ITEM # 2.0

**PRELIMINARY & FINAL
REPLAT APPROVAL:**

Replat of Hutton No. 3 Subdivision
Being a 4.510 acres, part of Lot 1 of the
Hutton No. 3 Subdivision
Suburban ETJ
Developer: HuttonCo Development, LP
Engineer: Dirksen Engineering

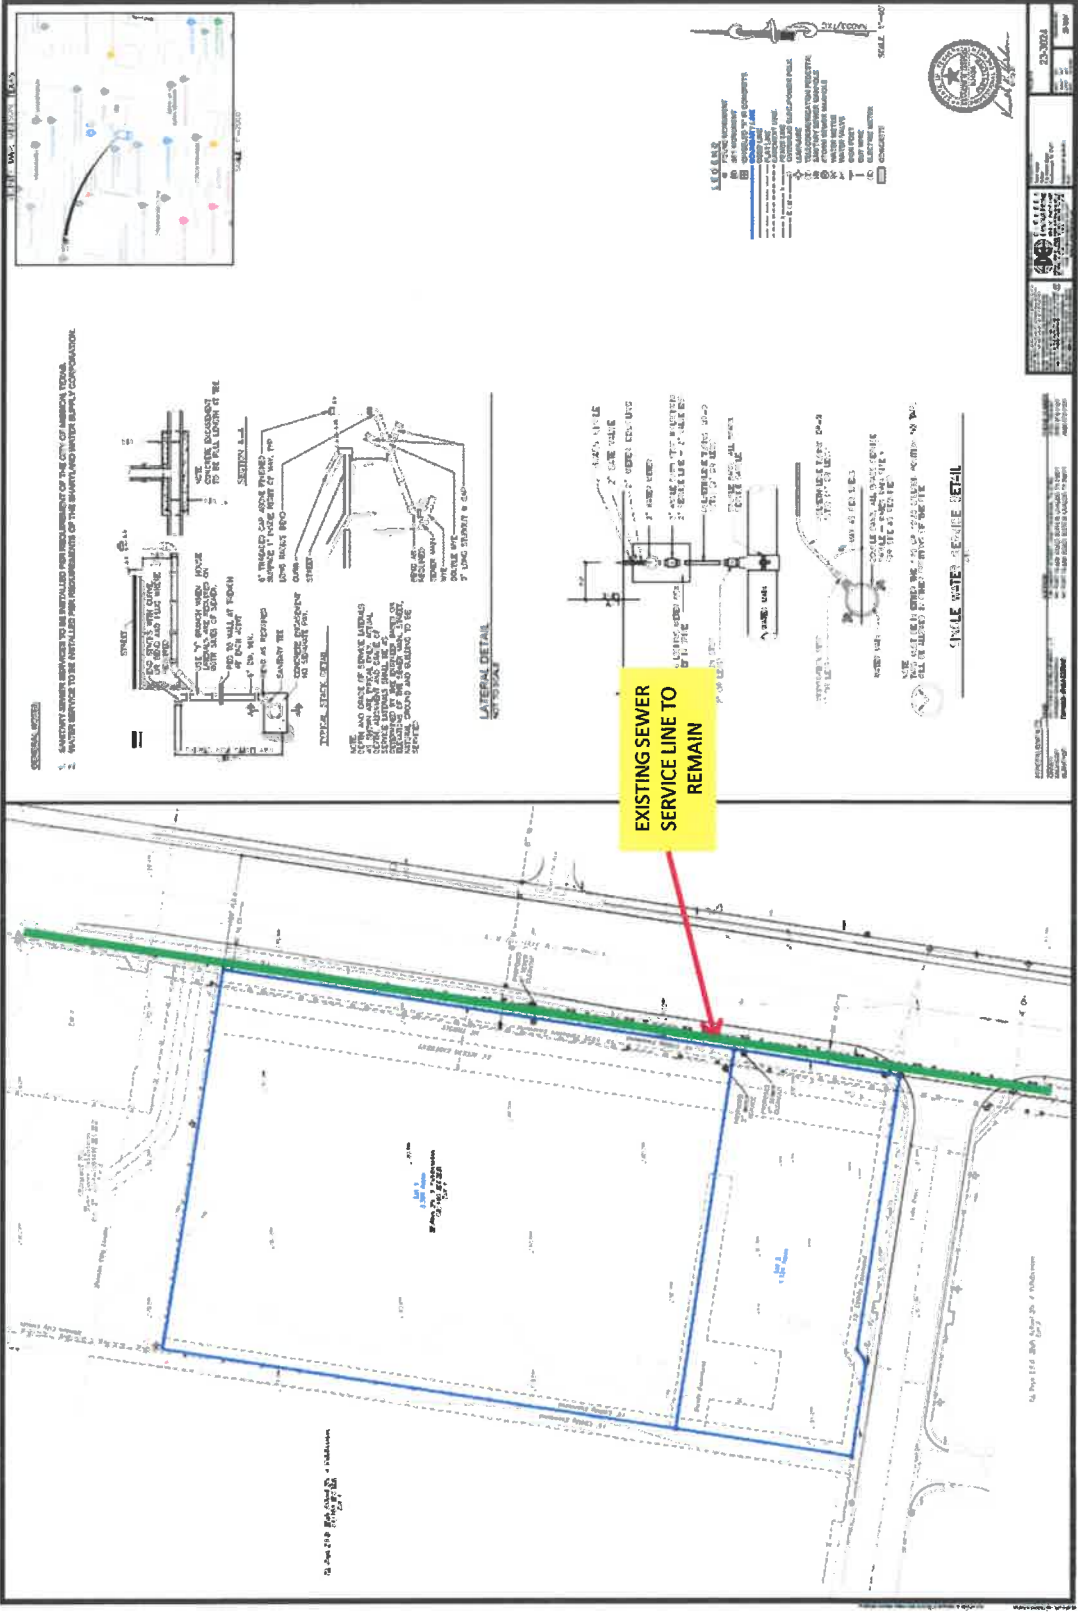
The water CCN belongs to Sharyland Water Supply Corporation. Existing fire hydrants are considered available therefore no further requirements are needed. — **see utility plan**
